**BASALT WASTE ISOLATION PROJECT REVIEW  
BY PACIFIC NORTHWEST LABORATORY'S REVIEW TEAM**

**Letter Report**

**November 1983**

**Prepared for the  
Richland Operations Office  
U.S. Department of Energy  
under Contract DE-AC06-76RLO 1830**

FIGURE 2.1. Small-Scale Structural and Stratigraphic Discontinuities in the Umtanum, Flow at the Emerson Nipple Section. (Source: SCR Figure 3-29, page 2.5-30).

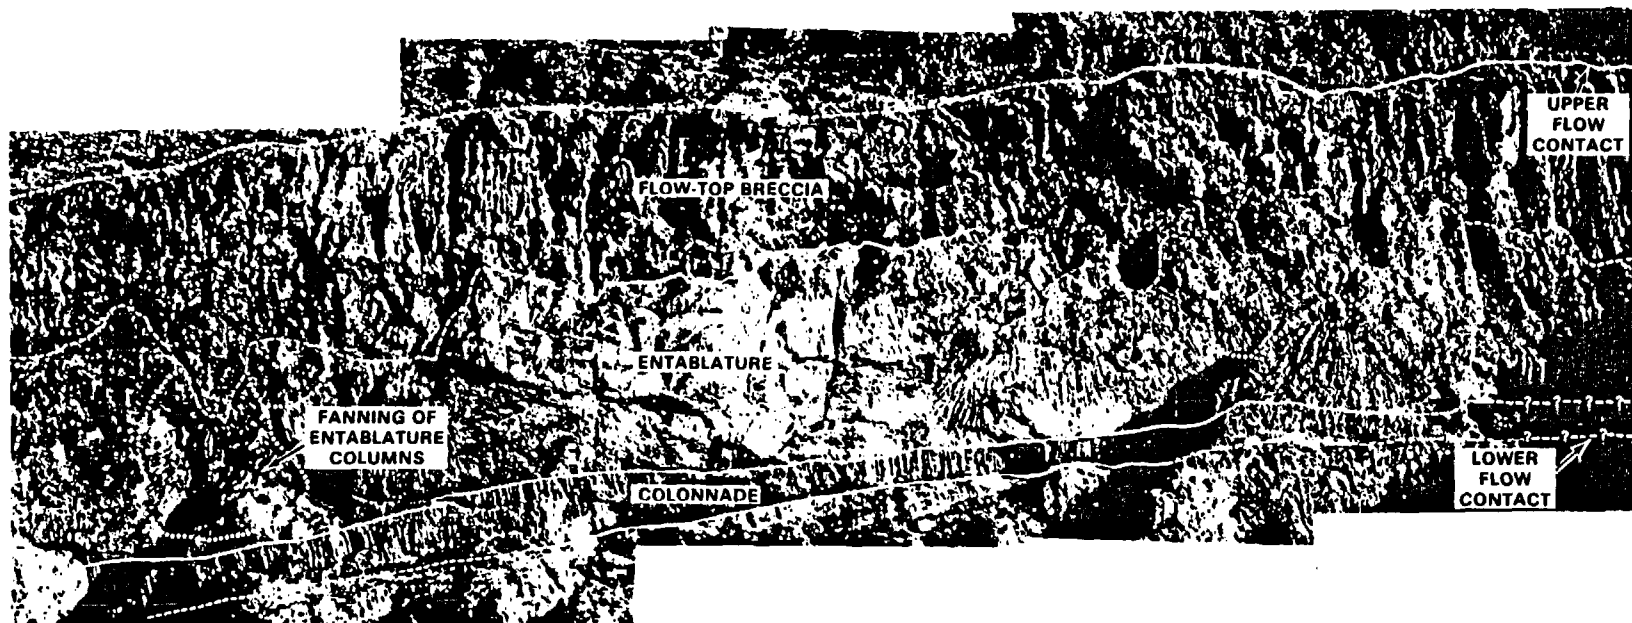
One unresolved technical question is the thickness and lateral extent of the candidate basalt flows. This particular question has gained significant attention since drilling RRL2. The brecciated flow-top for the Umtanum was found to be 148 ft, which nominally represents 64% of the total flow thickness of 197 to 231 ft. The conclusion was that localized thickening or thinning in the flow-top and related fanning joints occur in the reference repository location. Several stratigraphic features that may be encountered during the construction of the miles of tunnels for a repository include: "(1) locally thickened flow-top breccia (i.e., the partially welded broken rock formed in the upper part of a flow by explosion or flowage of a partly congealed basalt flow), (2) zones of potentially high vertical permeability formed by emplacement and cooling of the lava flows (e.g., margins of individual flows, zones formed by interaction of hot basalt and water, and joints formed by cooling but not sealed by secondary mineralization), and (3) faults, particularly the strike-slip variety and shear zones" (USGS, 7/28/83). Although Figure 3-29 of the SCR (1982) is likely an extreme example, it is reproduced here to lend perspective on this intraflow stratigraphy question (Figure 2.1). Examples of intraflow structural and stratigraphic discontinuities in the flow are depicted in this photograph of the Emerson Nipple outcrop.

It is difficult to predict the probability of encountering one or more of these potentially pressurized (1500 psi), water-bearing zones at depth; and the regional paleogeology would support the assertion that the probabilities may vary significantly from flow to flow. Based upon a limited analysis of basalt outcrops, the USGS staff suggest that the chance of encountering such intraflow anomalies might be on the order of 5 to 25% for the Umtanum flow and somewhat less for the Cohasset (USGS, 7/28/83). Regardless of the range of

estimates, it seems clear that there is a reasonable possibility of encountering intraflow discontinuities during repository construction. Detailed contingency plans should be established to deal with the possibility of mining into a high pressure, high permeability water-bearing zone (see Section 2.3 on BWIP plans).

**FIGURE 2.2.** S-W/N-E Stratigraphic Cross-section as Inferred from Initial Interpretation of Magnetotelluric Survey Data (after Halpin, 1982)

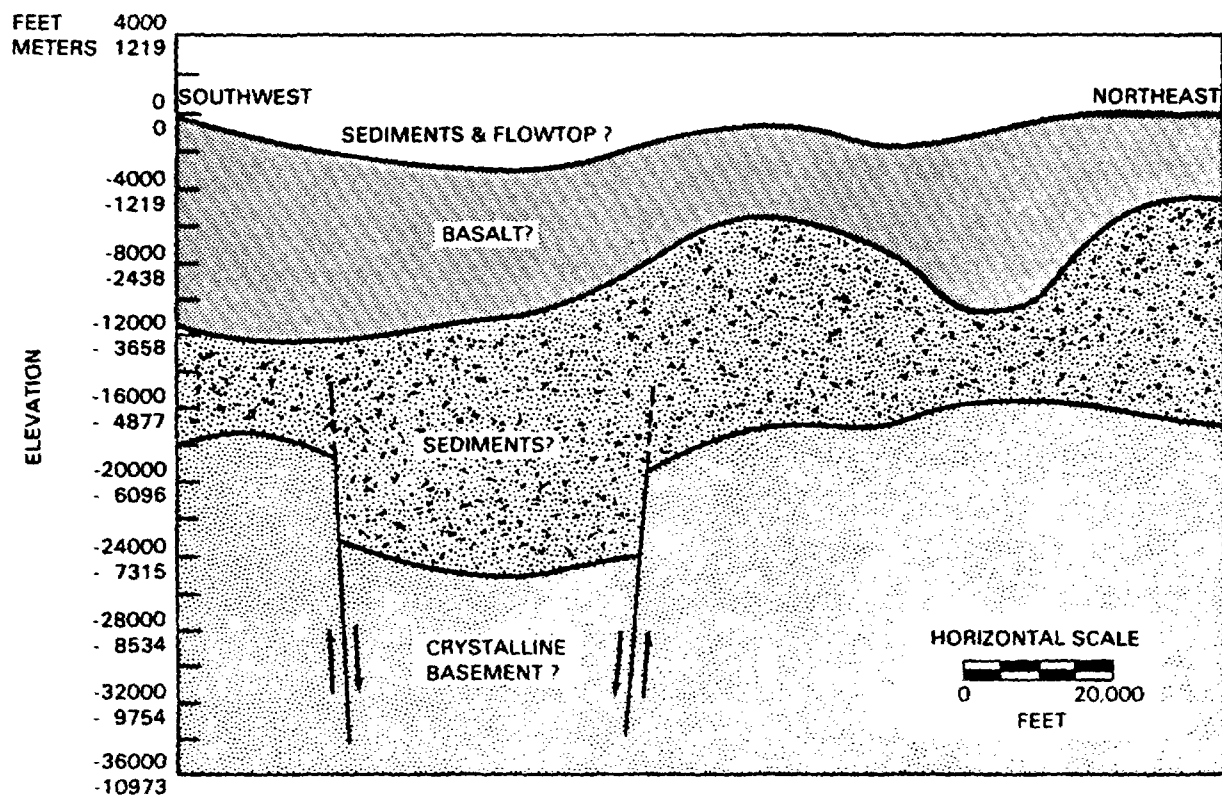
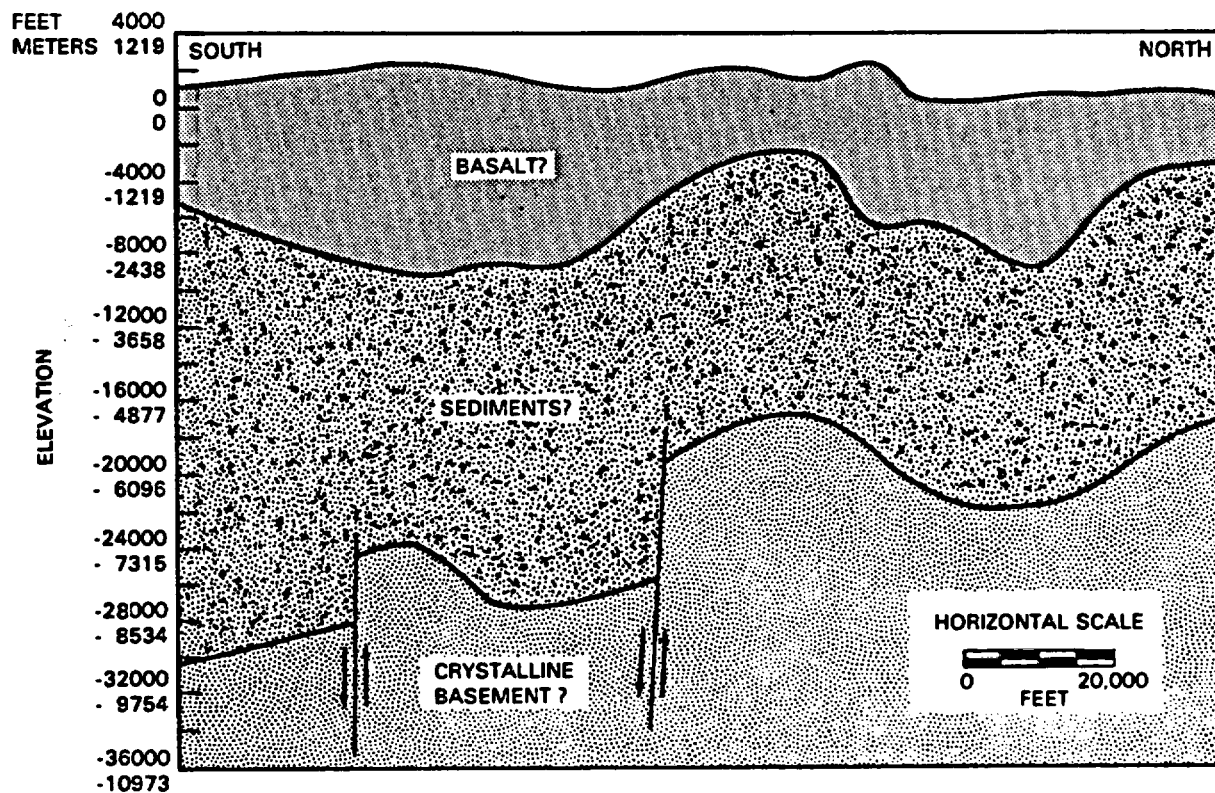
The reader is cautioned not to derive premature conclusions from these interpreted crosssections. For example, the block faulting depicted in the figures is a subject of considerable controversy and may or may not actually exist. Consequently, no locations are provided in the figures, though the crosssections are essentially contained on the Hanford site. The various layers depicted in the crosssections generally refer to: (1) the relatively conductive sediments plus the upper brecciated basalt flowtop overlying the uppermost basalt layer; (2) the relatively resistive sequence of basalts; (3) the relatively conductive layer below the basalts, inferred to be sedimentary material; and (4) the lowest resistive layer, generally inferred to be a crystalline basement rock.

There are tremendous difficulties and uncertainties associated with characterizing the deep stratigraphy and structure as depicted in the figures and subsequently correlating this with surface or near-surface features. The primary methods for characterization are: 1) geophysical analyses (e.g., magnetotelluric, gravity, magnetic, seismic reflection, and seismic refraction) and 2) geological extrapolations from available outcrops. For example, the magnetotelluric data shown in the figures may have a resolution of 10 to 20% (Price, 9/18/83). However, this assumption has not and apparently cannot be

validated for basalt at this time because geophysical techniques have not been calibrated or tested for sensitivity at a basalt site. Furthermore, the magnetotelluric interpretation presented in the figures was based upon the assumption of lateral continuity of the electric resistance of the inferred sediments below the basalt. An alternative assumption is to fix the continuous lateral resistivity of the basalts and allow the value of the sediments to float in a constrained manner. This alternative interpretation (which was in draft format and not available for this report) appears to reduce significantly the vertical relief at the base of the basalt sequence (basalt/sediment interface), typically smoothing across extremely thick or thin areas of the basalt. More dramatic structure is thus transferred to the interface between the sediment/crystalline basement.

FIGURE 2.4. Working Draft Geophysical Feature Map (ST-14)

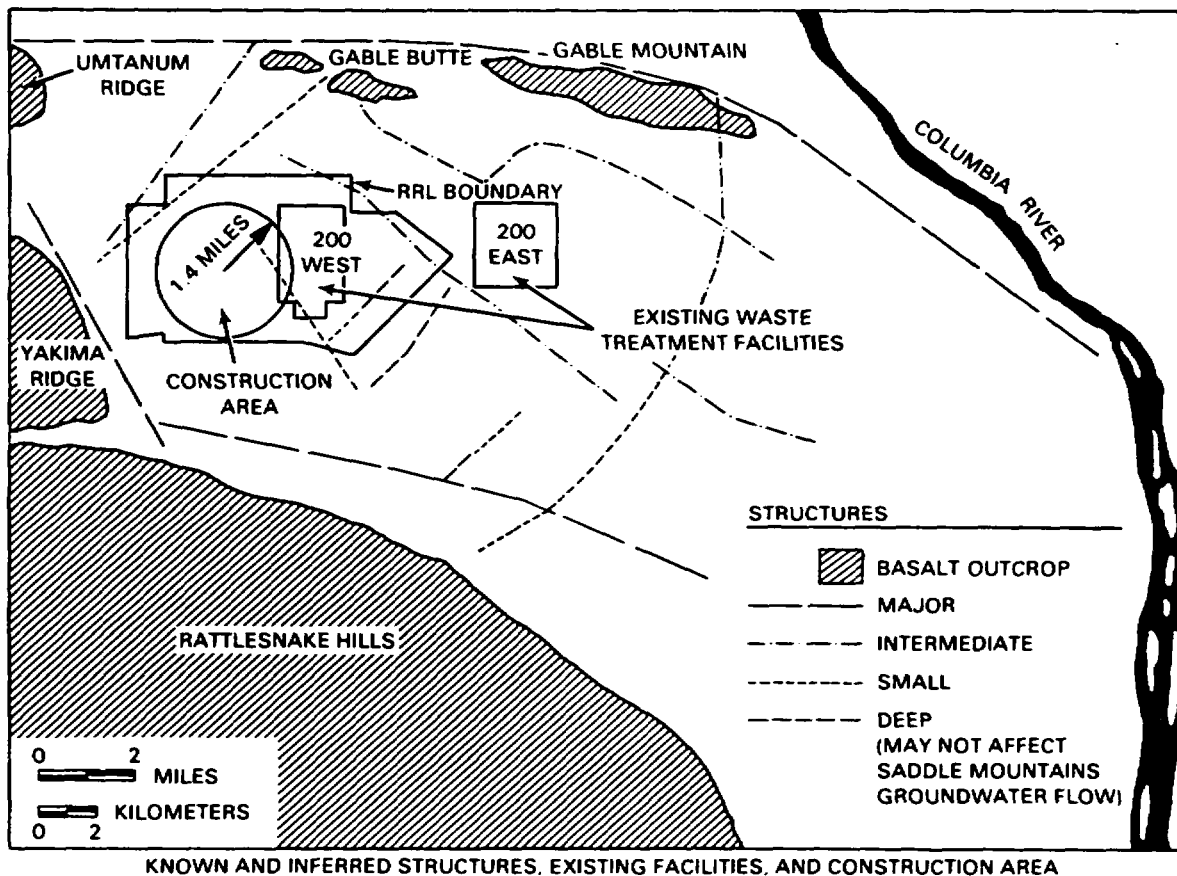
"The Yakima Barricade Area contains both the Nancy linear and the Hydrologic Barrier anomaly. This area is important because of the anomalous hydrologic heads that have been observed and because many of the aeromagnetic anomalies trend into the RRL."

"The northern extension of the RAW past Snively Basin, the Hanson Creek anomaly and the Hog Ranch/N-S gravity gradient are all features that remain unresolved and warrant investigation. Of particular importance is the potential for structures splaying off the aforementioned features into the RRL."

"The eastward extension of Yakima Ridge has been traced by gravity, aeromagnetics, and ground magnetics. Several crosscutting anomalies have been detected (primarily NW trending). Two N-W trending, aeromagnetic features are also located within the RRL. These anomalies, D-218 and N512, have weak aeromagnetic signatures, but because N-512 is also detected via bouguer gravity and both features are located near the proposed site for the exploratory shaft, their identity should be resolved."

FIGURE 6.1. Approximate Relationship Between Excavation Stability, Rock Mass Quality, or Rock Mass Rating and Maximum Compressive Boundary Stress (after Hoek, 1981)

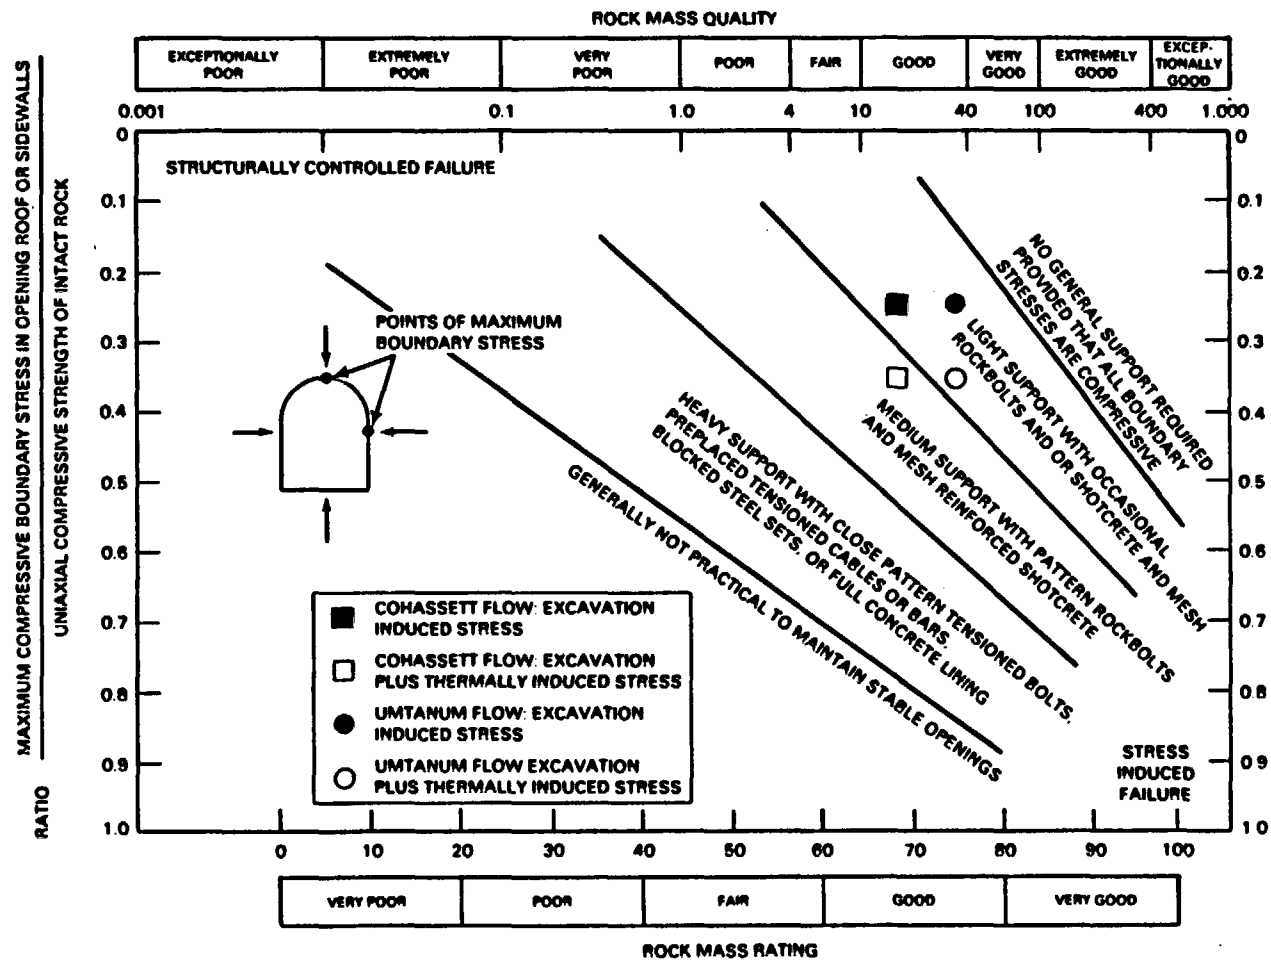
In the analysis, RHO estimated the maximum compressive boundary stress by assuming a horizontal to vertical stress ratio of 2:1 and a stress concentration factor for an elliptical opening. The uniaxial strength was estimated to be 364 MPa, based on the intact strength of Umtanum basalt. The intersection of the parameters is illustrated in Figure 6.1. The conclusions of the analysis were:

PNL has expressed concern that the various rock mass rating parameters had not been adjusted for the specific conditions present in the Hanford basalt. In addition, the intact strength values used did not consider all of the candidate basalts and the uncertainty of the data. PNL provided other support estimates using existing data and the Hoek diagram. The data represented the worst rock strength values and lowest rock mass rating values and resulted in a considerably higher support requirements. The intention of PNL was to demonstrate the range of conditions and attendant conclusions that could be encountered and to encourage a more thorough treatment of the data.

Laubscher and Taylor (1976) and Kendorski et al. (1982) have developed methodologies for adjusting the rock mass rating for various conditions. The conditions include: Number of tunnels (tunnel interactions), Excavation method

The effect of these adjustments is a lowering of the rock mass rating and a more conservative estimate of the rock support requirements. No evidence has been found that any of the adjustments of the rating system parameters were made by RHO . However, in a later draft of the RHO-BWI-ST-28P-Draft, October 1983) the treatment of the intact strength data was considerably improved by taking a statistical approach to the data. These changes resulted in a more conservative support estimate with a majority of the Cohasset support requirements falling into the "medium support" region when the thermal stresses were added to the excavation induced stress.

**Figure 6.2.** Strength and Modulus as Function of Temperature (Schmidt, 1981)

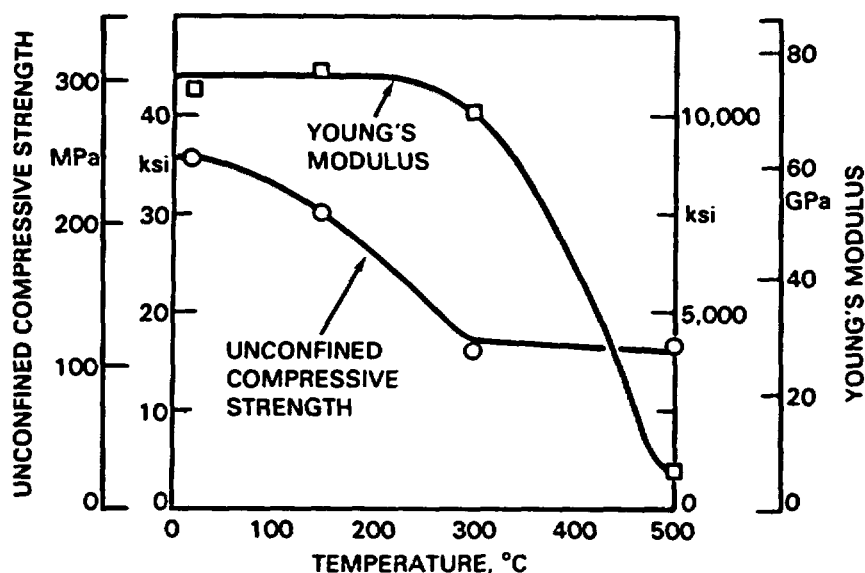
There is some evidence that the strength of basalt may decrease with increasing temperature. Parsons Brinckerhoff has reported a decrease in rock strength with increasing temperature and proposed the relationship in Figure 6.2. (Schmidt, 1980, 1981) the chart is based on laboratory strength tests at elevated temperatures performed by the Colorado School of Mines (CSM, 1979,

a,b). Foundation Sciences, Inc. (FSI) reported as much as a 50% decrease in intact basalt strength with increasing temperatures (300°C) (RHO-BWI-C-100, 1981). RHO decided to disregard the results due to quality assurance questions regarding the basalt samples used. However, both results indicate a lowering of basalt strength at high temperatures. Referring to Hoek's chart, a lower value of strength results in a greater stress to strength ratio and an increase in the recommended support requirements. Further investigations are necessary to establish the effect elevated temperatures have on the strength of basalt.

FIGURE 6.3. Approximate Relationship Between Excavation Stability, Rock Mass Quality or Rock Mass-Rating and Maximum Compressive Boundary Stress (after Hoek, 1981)

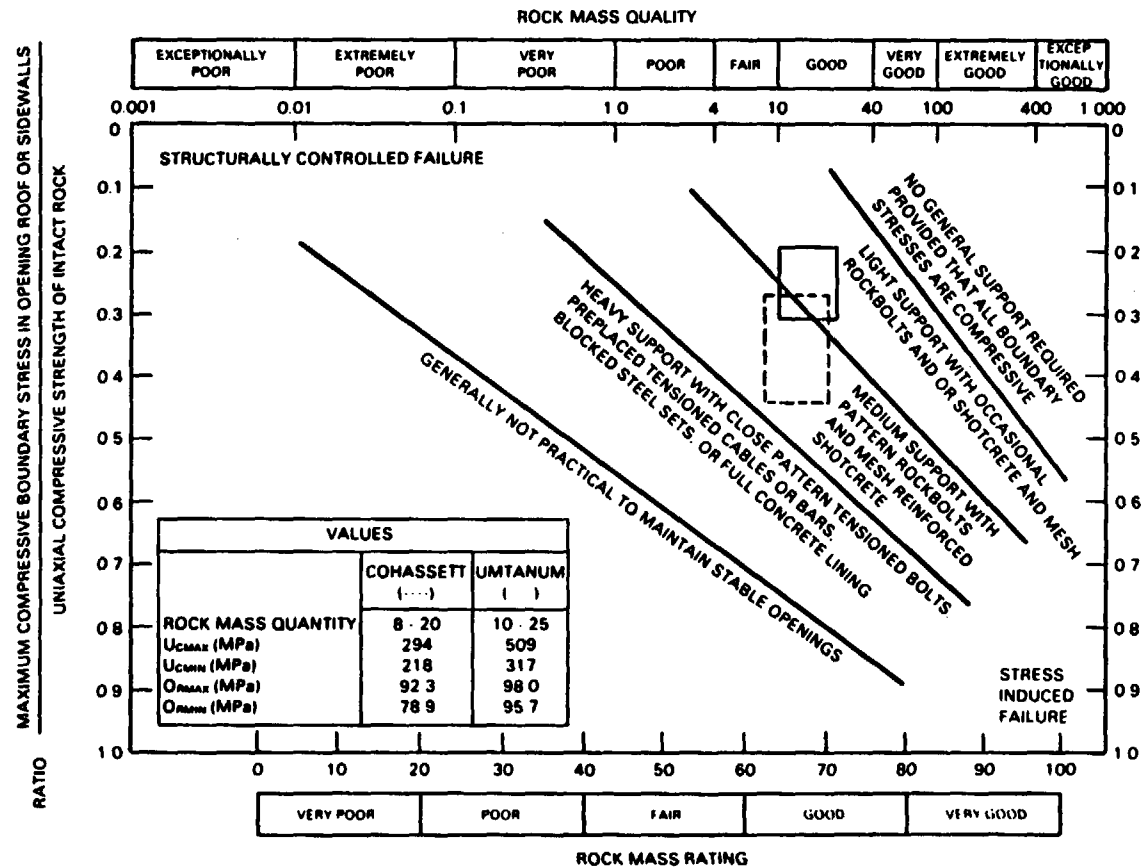
The intersection of the parameters on Hoek's chart is illustrated in Figure 6.3. The revised support estimates are:

(Umtanum) "mostly 'light support with occasional rockbolts and/or shotcrete and mesh'. However, heavier support would be required if flow-top breccia were encountered.....These areas with apparently weaker joints could require 'medium support'."
